**RESPONSE TO PEER REVIEW COMMENTS ON THE
MAY 2012 AND APRIL 2013 DRAFTS OF**

***AN ASSESSMENT OF POTENTIAL MINING IMPACTS ON SALMON
ECOSYSTEMS OF BRISTOL BAY, ALASKA***

U.S. Environmental Protection Agency

This document presents (1) an overview of the peer review process, (2) all of the peer reviewers' comments on both the May 2012 and April 2013 drafts of the assessment, and (3) EPA's responses to the peer reviewers' comments.

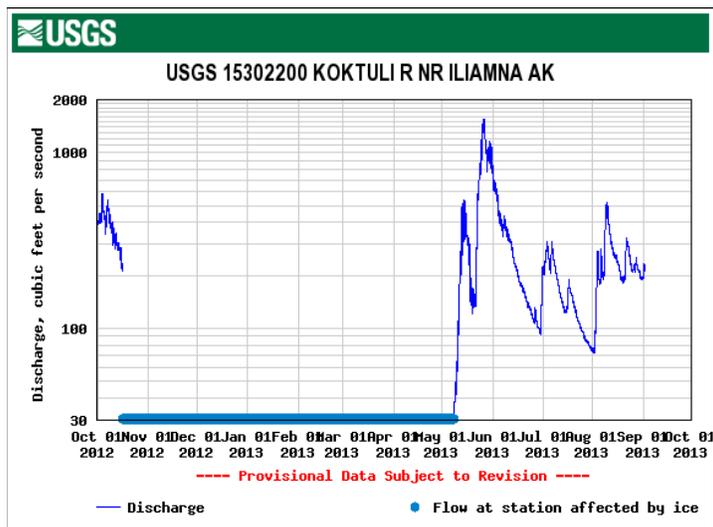
4. Groundwater exchange and flow stability make for more stable habitat? Meaning is unclear.

EPA FINAL RESPONSE: This statement has been clarified to indicate that higher proportions of groundwater contribute to more moderated flow regimes with lower peak flows and higher base flows, thus creating a less temporally-variable hydraulic environment.
